**CATEGORY II AIRFRAME AND
SUBSYSTEMS EVALUATION**

SUBJECT ASD Addendum Report to FTC-TR-71-37, UH-1N Airframe and
Subsystems Evaluation

This report is a part of and should remain attached to FTC-TR-71-37, UH-1N Airframe and Subsystems Evaluation. The paragraph numbers below correspond to recommendations in the AFFTC Technical Report.

Figure 21 IFF Antenna Patterns

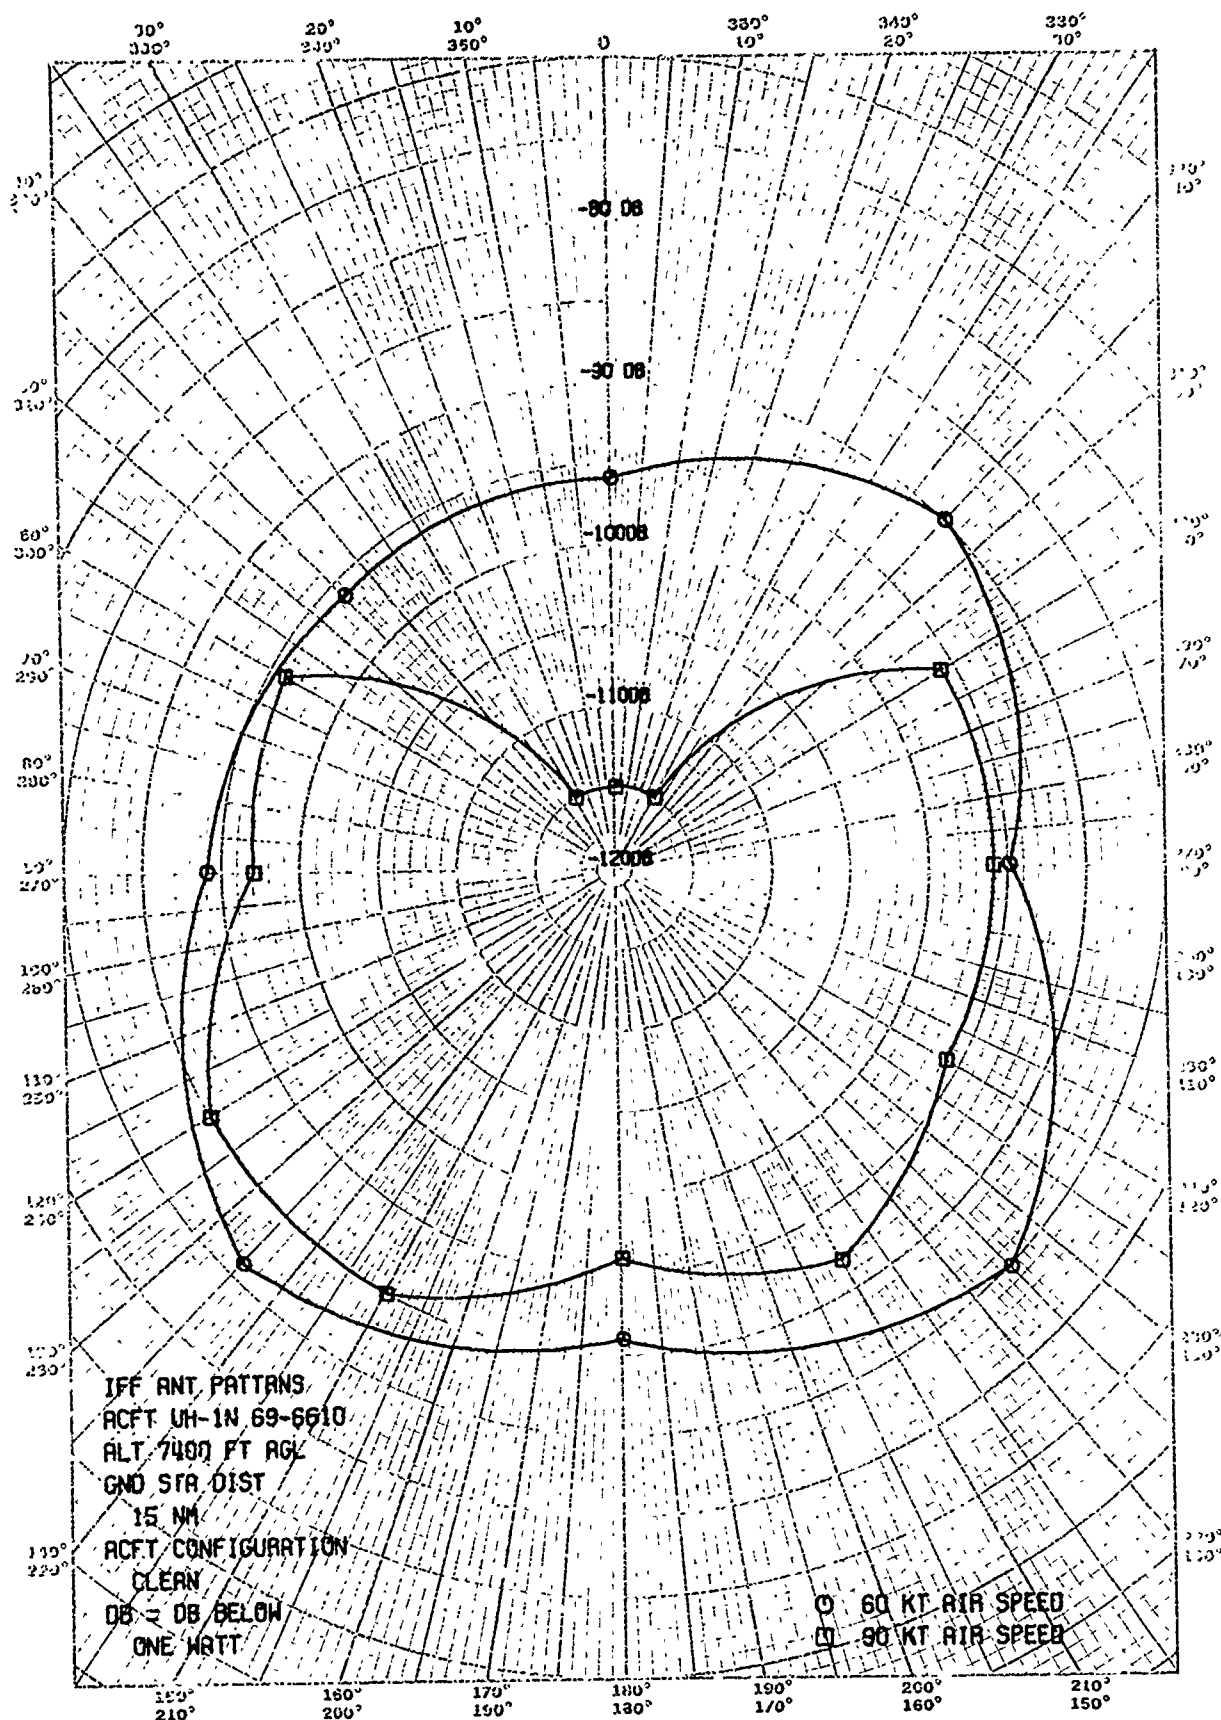
The radiation pattern of the AT-741A Antenna was measured by flying cloverleaf patterns over a point 15 NM from the PACF, at 10,000 feet pressure altitude. Radar tracking was used to vector the aircraft over the reference point on each heading. The relative signal strength was measured while interrogating the transponder in mode 2. The UH-1N aircraft used one IFF antenna located on the bottom of the aircraft near the rear of the fuselage. The antenna radiation pattern obtained at 90 KIAS (figure 21) was unacceptable due to the deep null off the nose of the aircraft. This null was not observed at 60 KIAS, when the nose-down attitude of the aircraft decreased approximately 4 degrees. An additional top-mounted fuselage antenna with an antenna switching unit should be installed to improve the radiation pattern. (R 31)

31. Concur. ASD will request an ECP to correct this deficiency. An additional IFF antenna and SA-1474/A switching unit may be required.
